# Author Comments (ACs)

Tang, G., Nicholls, Z., Jones, C., Gasser, T., Norton, A., Ziehn, T., Romero-Prieto, A., and Meinshausen, M.: Investigating Carbon and Nitrogen Conservation in Reported CMIP6 Earth System Model Data, EGU sphere [preprint], <https://doi.org/10.5194/egusphere-2024-3522>, 2024.

# RC1: 'Comment on egusphere-2024-3522', Anonymous Referee #1, 20 Dec 2024

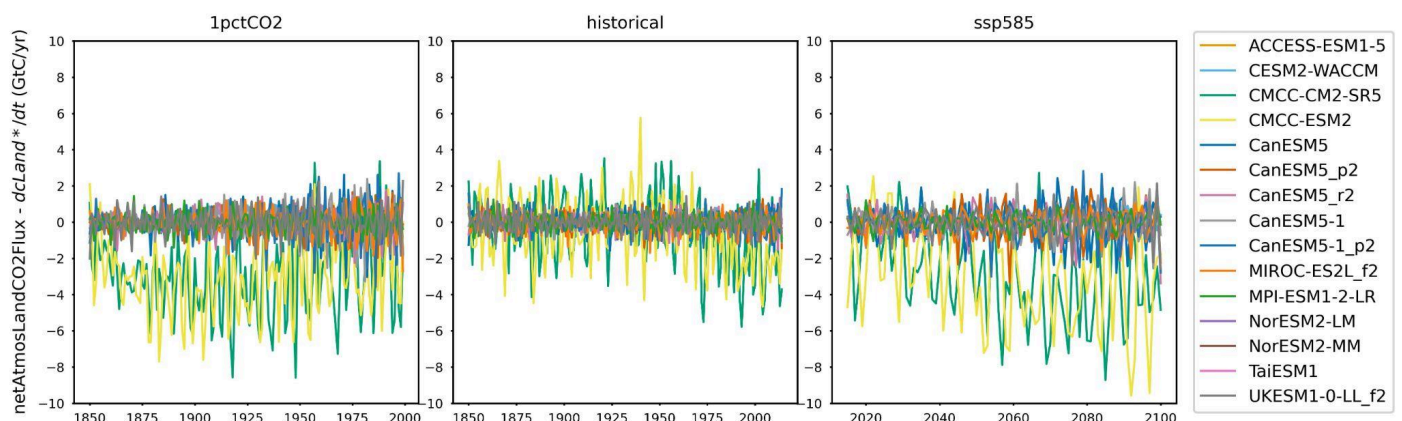
Fig. A4. Please extend the y-axis to fully display the negative values.

GT: Thanks we have updated the figure A4.
